Document Information			
Document #	0201741/02-RCA-0272	**Revision**	
Title	QUARTERLY NOTIFICATION OF CLASS 1 MODIFICATIONS TO THE HANFORD FACILITY RESOURCE CONSERVATION AND RECOVERY ACT (RCRA) PERMIT, DANGEROUS WASTE PORTION (QUARTER ENDING MARCH 31, 2002 - PERMIT CONDITION I.C.3)		
Date	04/09/2002		
Originator	J. HEBDON, R. H. GURSKE, R. D.(ROBY) ENGE	**Originator Co.**	DOE, FH, PNNL
Recipient	L. E. RUUD	**Recipient Co.**	DOEC
References			
Keywords			
Projects			
Other Information

APPENDIX 4B

DETAILED DRAWINGS FOR THE 200 AREA EFFLUENT TREATMENT FACILITY CONTAINER STORAGE AREA AND TANK SYSTEMS

ENGINEERING CHANGE NOTICE

Ref Dwg	Sh	Rev
H-2-88982	1	12

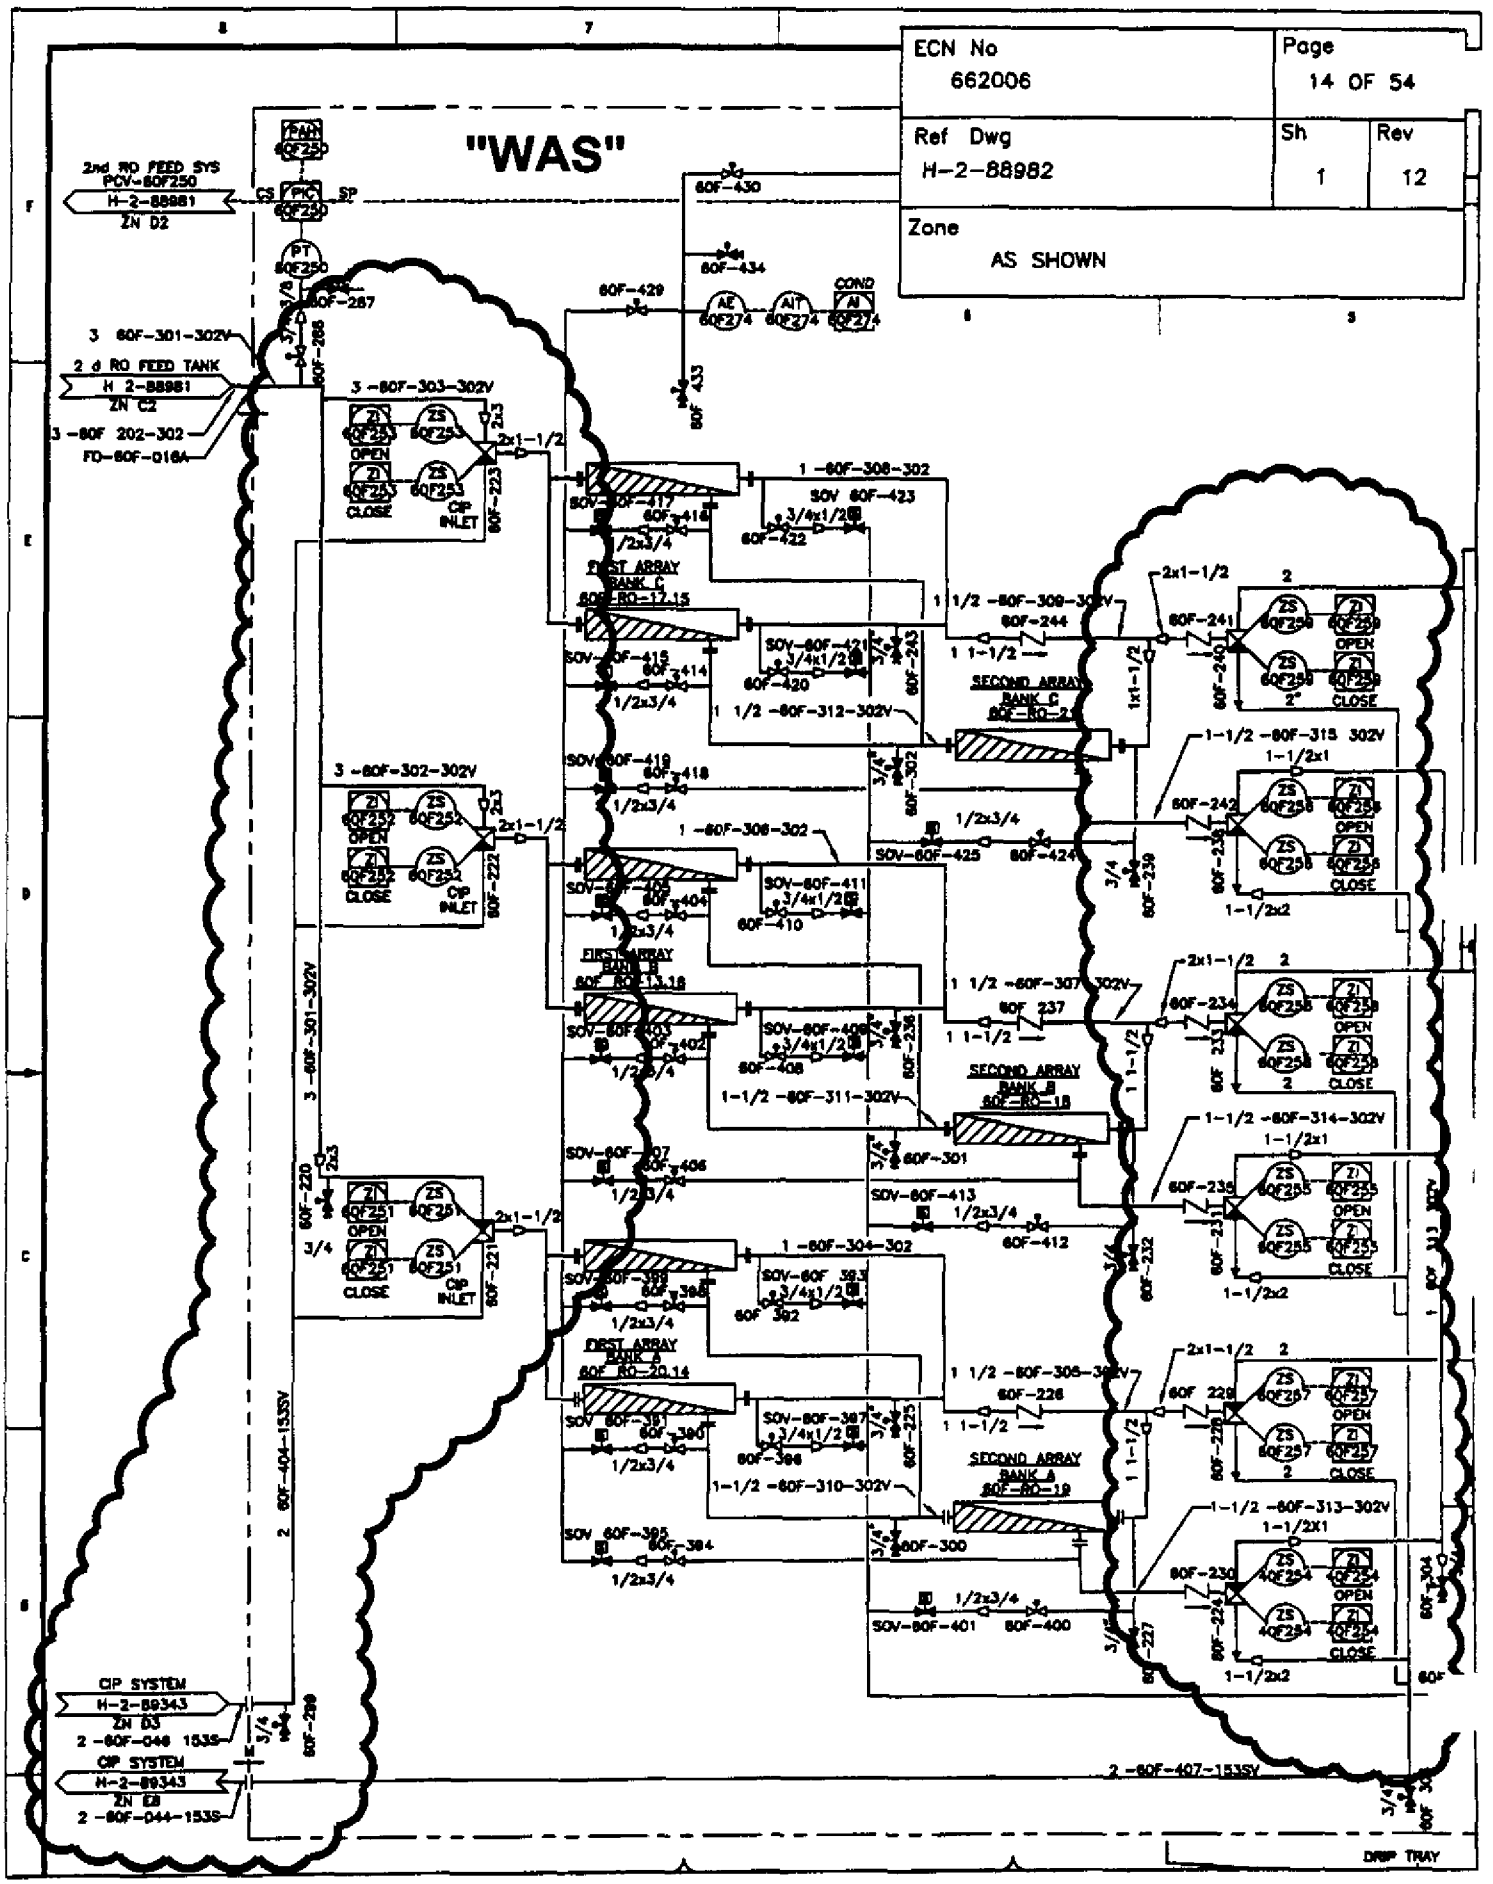
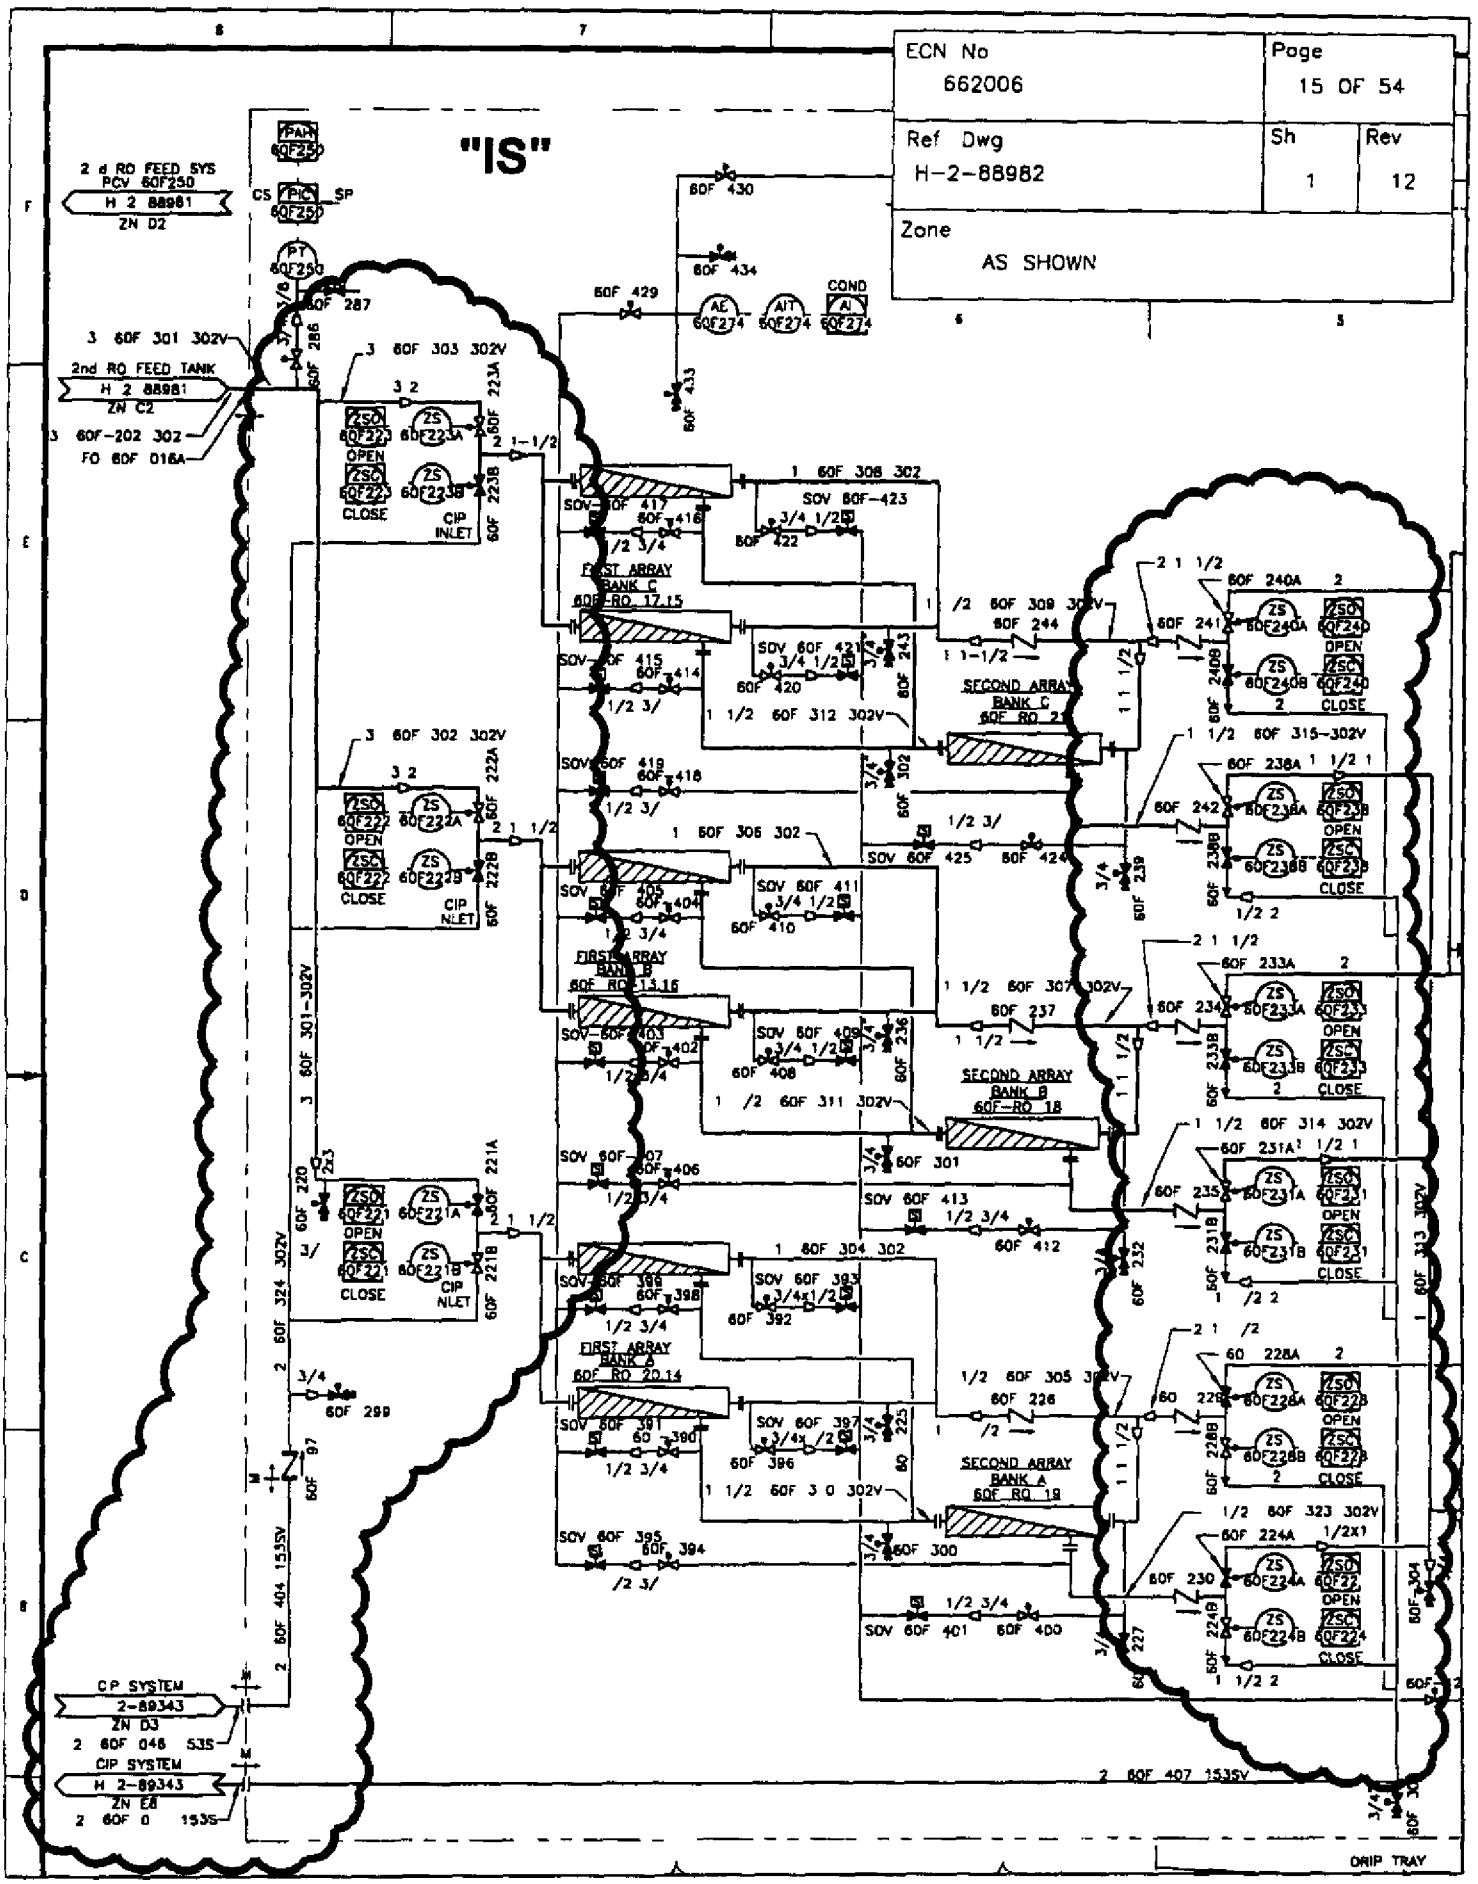
Remove and replace 3-Way ball valve 60F-117 with two 2-Way ball valves Label new valve upstream of pipeline 2 -60F-128-153SV with valve number 60F-117A Label other new 2-way valve 60F-117B

Show valve 60F-117A as open and valve 60F-117B as closed

Remove and replace 3-Way ball valve 60F-114 with two 2-Way ball valves Label new valve upstream of pipeline 2 -60F-107-302V with valve number 60F-114A Label other new 2-way valve 60F-114B

Show valve 60F-114A as open and valve 60F-114B as closed

Correct orientation of pipe reducer shown upstream check valve 60F-115

ECN 647247 - 8/27/98
Page 9 of 12
Block 13a Cont d
H 2-817976 Sh 1 Rev 1
Zones A4-D6
IS NOW

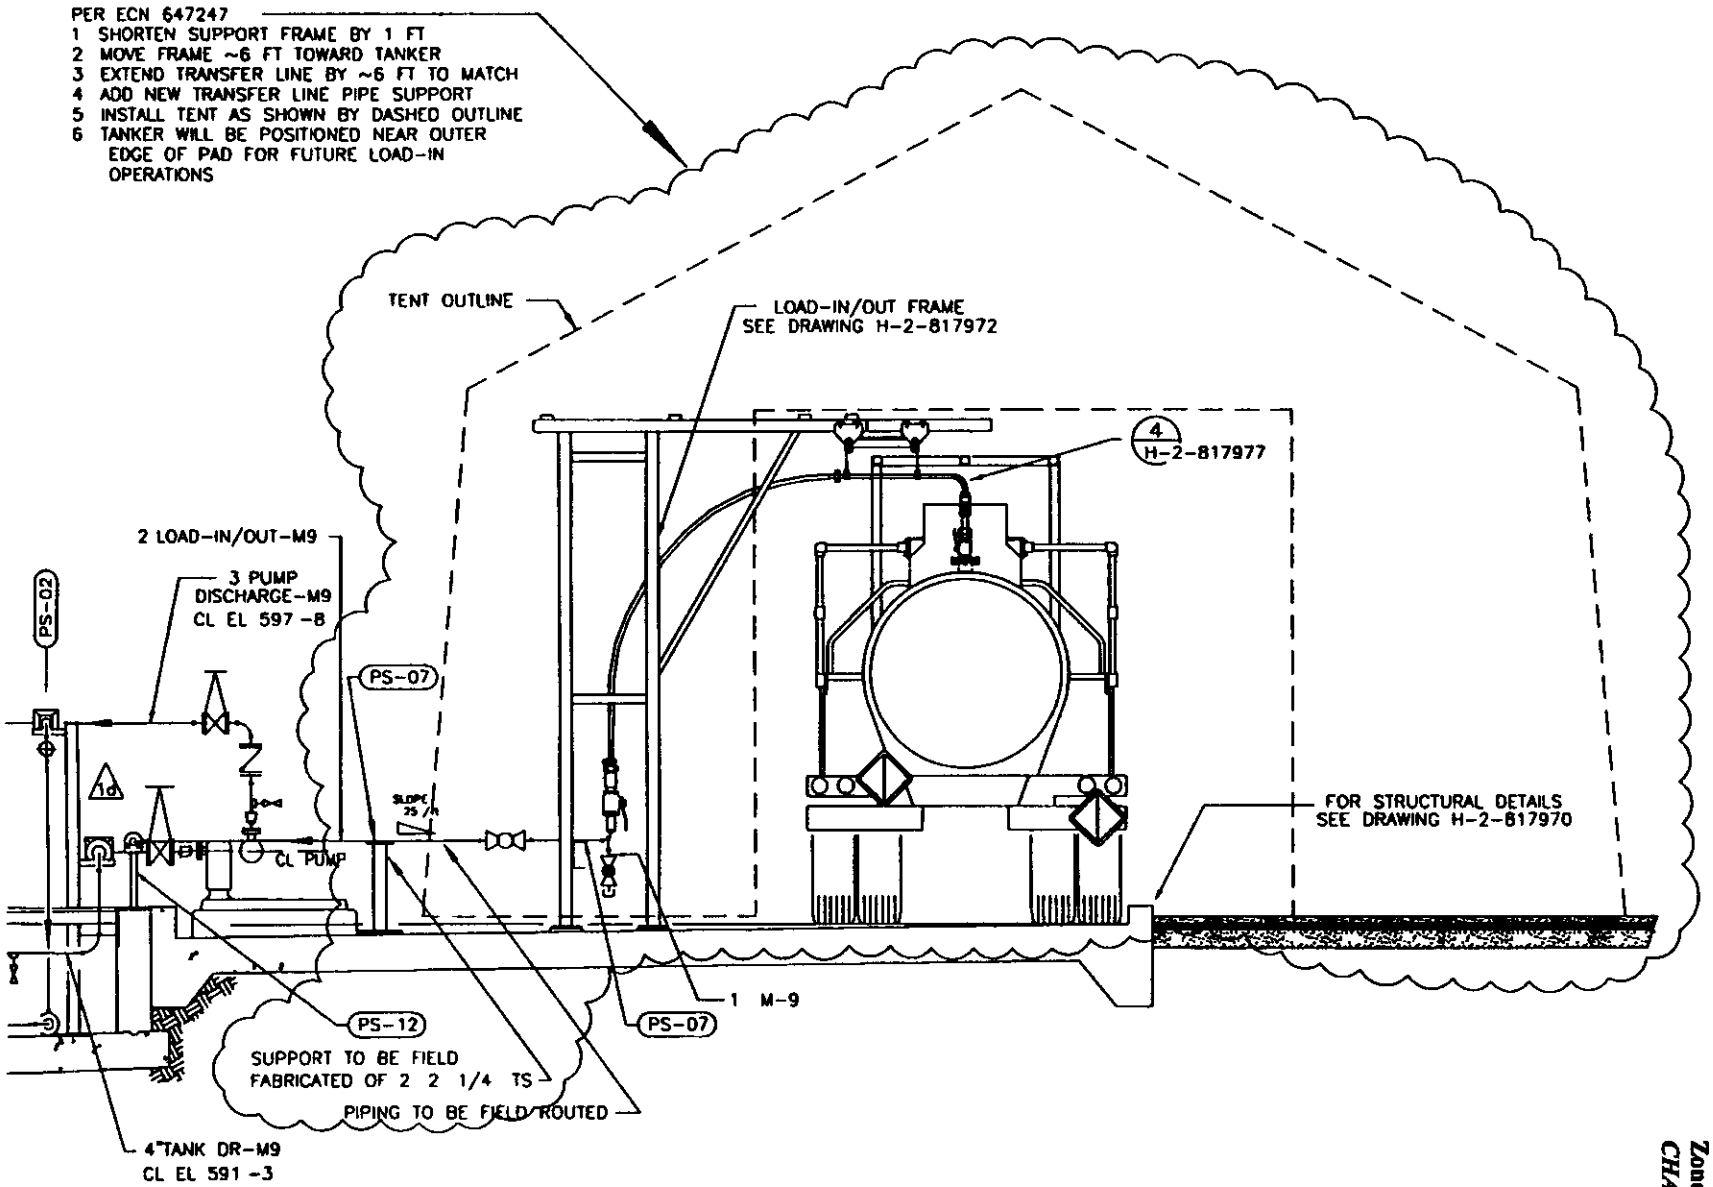
ECN 647247 – 8/27/98
Page 10 of 10
Block 13a Cont d
H 2 817976 Sh 1 Rev 1
Zones A4–D6
CHANGE TO
